Access Compliance Report

Public Rights-of-Way

Intersection ID: 11551	Main Street: E_16TH_ST	Cross Street: N_CALDWELL_ST	Location: W
ADA ID: F48CC93C1159	Ramp Type: BlendTrans2	Initial Pass/Fail: Fail	Overall Compliance: No
		Severity Score: 8.75

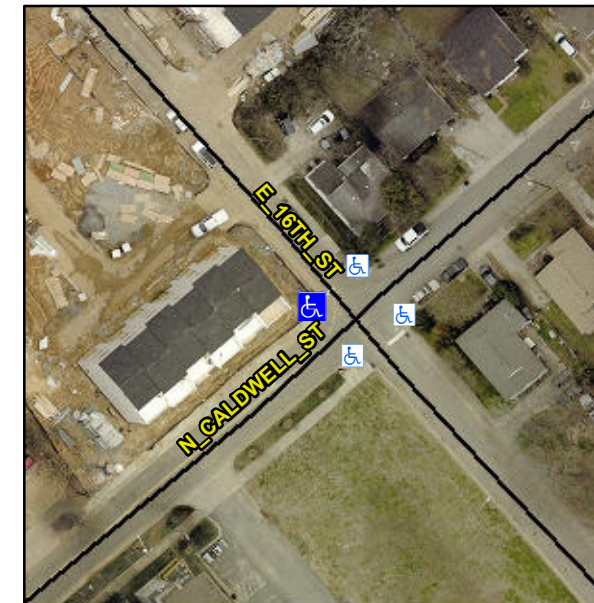
Not Found, R304.5.1

Compliance	Description	Data	Compliance	Description	Data
N/A	Ramp Length (in)	57.0	Yes	BlendTrans Slope (%)	2.7
No	Ramp Width (in)	41.0	Yes	BlendTrans XSlope (%)	1.0
N/A	Flare Type LT	N/A	N/A	Flare Type RT	N/A
N/A	Flare Slope LT (%)	N/A	N/A	Flare Slope RT (%)	N/A
N/A	Flare Traversable LT?	N/A	N/A	Flare Traversable RT?	N/A
N/A	Landing Length (in)	N/A	N/A	DWS Provided?	N/A
N/A	Landing Width (in)	N/A	N/A	DWS Contrast?	N/A
N/A	Landing Slope (%)	N/A	N/A	DWS Length (in)	N/A
N/A	Landing X Slope (%)	N/A	N/A	DWS Full Width?	N/A
N/A	Landing Curb? (Y/N)	N/A	N/A	DWS Offset (in)	N/A
N/A	Shared Landing?	N/A			
N/A	Gutter Ponding?	Yes	N/A	Gutter Slope (%)	N/A
N/A	Gutter Lip Ht (in)	N/A	N/A	Gutter X Slope (%)	N/A
N/A	Painted X Walk1?	No	N/A	Painted X Walk2?	No
	X Walk 1 Direction	To SE		X Walk 2 Direction	To NE
	X Walk 1 Width (in)	N/A		X Walk 2 Width (in)	N/A
	X Walk 1 Slope (%)	4.4		X Walk 2 Slope (%)	5.4
	X Walk 1 X Slope (%)	1.2		X Walk 2 X Slope (%)	5.7

N/A	Ramp inside XWalk1?	N/A	N/A	Ramp inside XWalk2?	N/A
	Road Slope (%)	0.5		Clear Space?	N/A
	Road X Slope (%)	8.1	N/A	Clear Space to XWalk (in)	N/A
N/A	Any Obstructions?	N/A	N/A	Storm Grate/Utility Hazard?	N/A
	Obstruction Type			Storm Grate/Utility Type	
		N/A			N/A
		Yes		Surface Condition? (G/P)	Good
		No		Curb Slope (%)	12.9

Remove & Replace Curb Ramp With Two New Directional Ramps or Equivalent.
